May 2020 | Response to Comments on Mitigated Negative Declaration  
SCH # 2020029070

# DEL MAR HEIGHTS SCHOOL REBUILD PROJECT

Del Mar Union School District

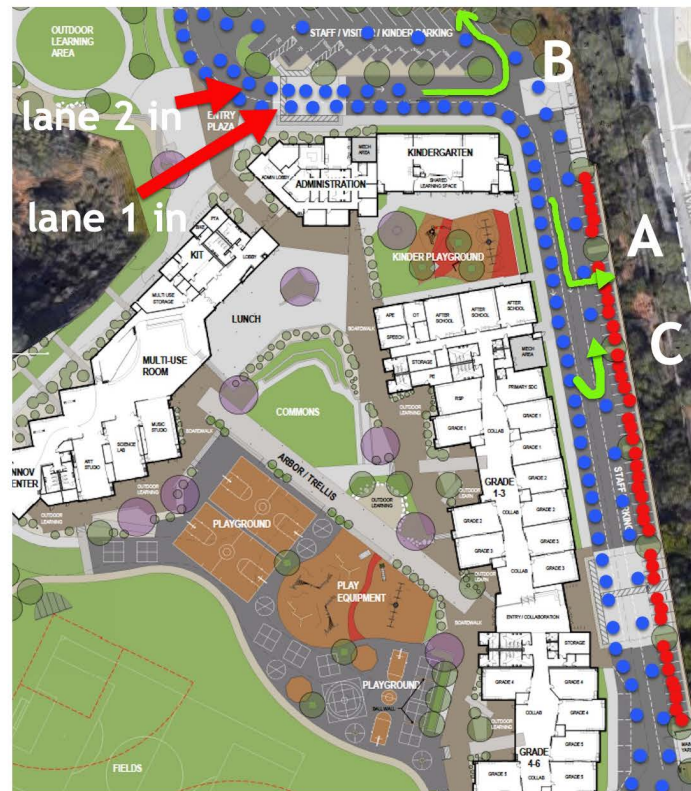
The three lane onsite queue combines emergency vehicle access, bi-directional traffic, drop-off, pick-up, merger of two lanes into one at the south turnaround, and forty-five 90° angle parking spots into a width that is seven feet narrower than Boquita Drive. Once you get in, if you follow the rules, you are stuck until you go all the way to the south roundabout and make your way back. Every one of the forty-five staff parking spots pulls out into the single outbound lane of the queue. If you want to park in one of the staff spots, you must wait until you get to the turnaround and head back north - assuming you follow the rules rather than just cut across traffic and grab an open spot.

Here’s the on-site queue, populated with incoming cars in blue at approximately the right density. The red cars arrived earlier and parked. The moving cars are packed tighter on the inbound, as you’d expect; and looser on the outbound, as you’d expect.

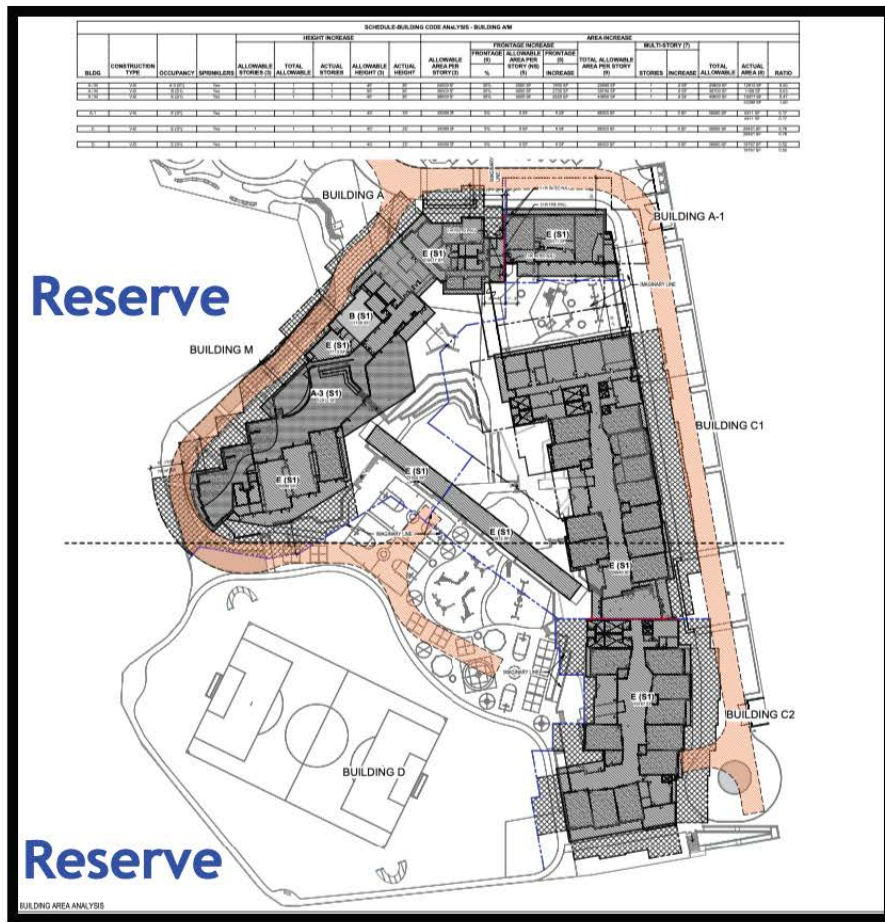
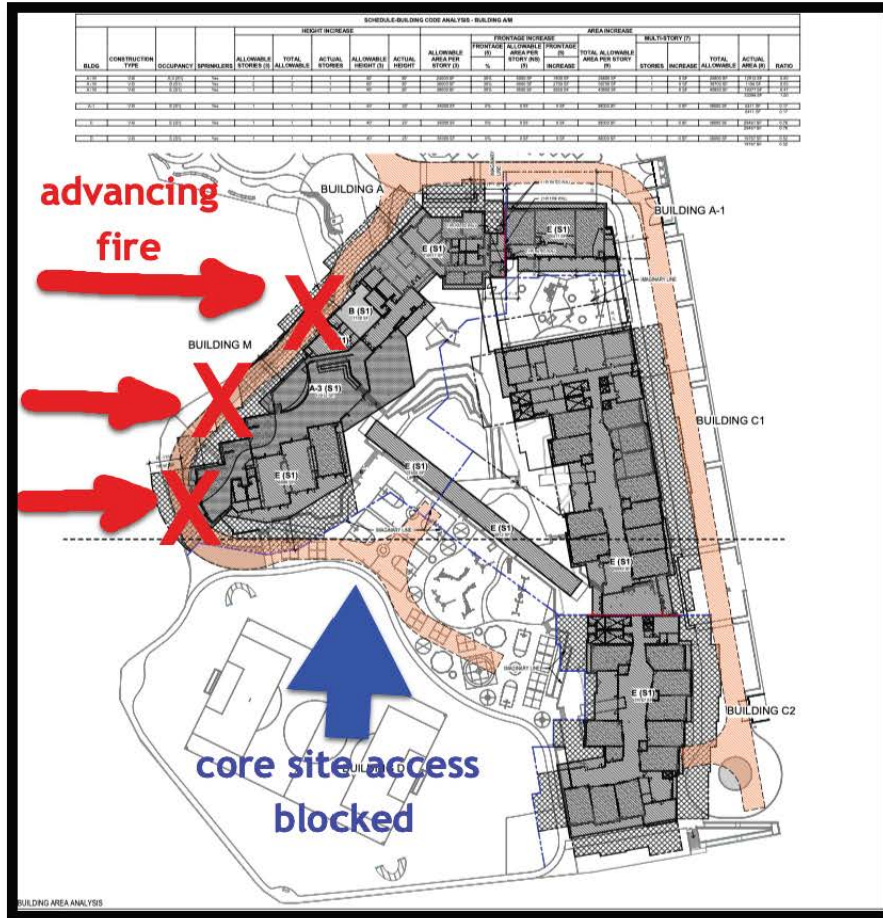
In the photo above, you can see the path a fire truck takes to gain site access today. Entry on Boquita, turn east and then move across the blacktop to the west - full site access and within 150' of every inch of every building, as required for non-sprinklered buildings.

If that happens **before** emergency vehicles get to the site, they might be blocked from accessing the school site core by the west road - which is the only way to get to the core. If it happens **after** emergency vehicles get to the site and make it to the core of the facilities, then they might not be able to get out - emergency personnel or victims could be stuck. The next figure illustrates this potential situation.

- JJ-146 The Board of Education will consider all comments in its deliberations concerning the project.
- J-147 See responses to J-98 and J-120.
- J-148-154 The existing fire access lane is inadequate as the width of the lane is only 10 feet between the edge of the slope and the building. The minimum width is 20 feet per the 2019 California Fire Code. The proposed fire lane is 20 feet in width throughout its length and it eliminates the existing restricted access point (see Figure 7, *Fire Access Lane*). The fire lane includes hammerhead turnarounds and the hose length distances are in compliance with the 2019 California Fire Code. Further, the plan has been reviewed and pre-approved by the City of San Diego Fire Marshall.

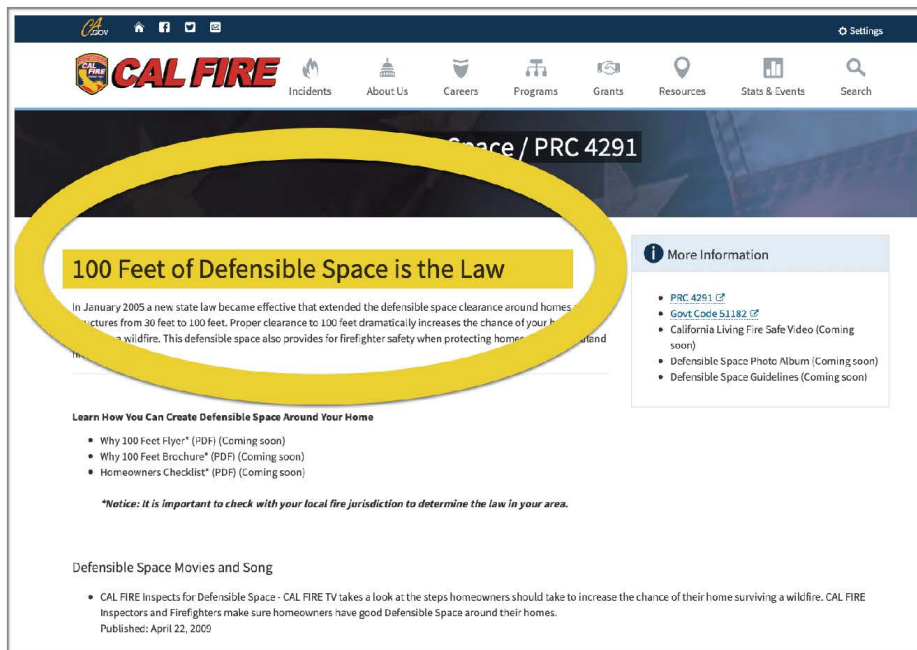
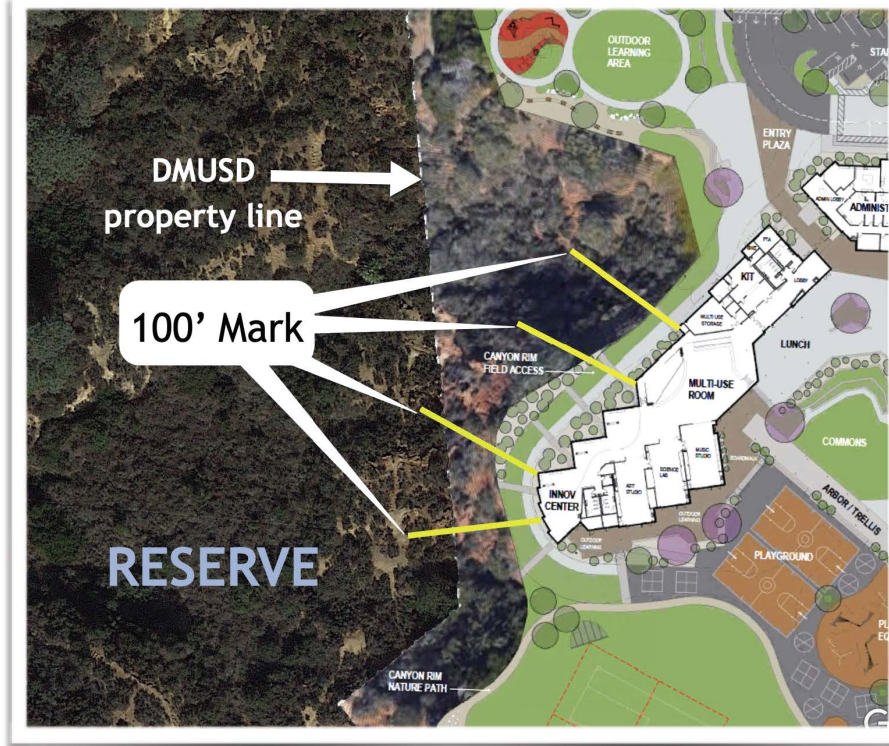
A core concept in reducing wildfire risk is the notion of “defensible space.” “Defensible Space is the area around a structure where combustible vegetation that can spread fire has been cleared, reduced or replaced. This space acts as a barrier between a structure and an advancing fire.”<sup>45</sup>

reserve. The yellow prongs (which we have added) show where 100' from the building walls ends, approximately. As you can see, there's a problem - it's far out into the heavily wooded areas adjacent the school, down the 38% slope we mentioned earlier, and then some.<sup>47</sup> The construction plans on file with the Division of State Architect acknowledge these areas are either "dense trees" or "dense brush."<sup>48</sup>
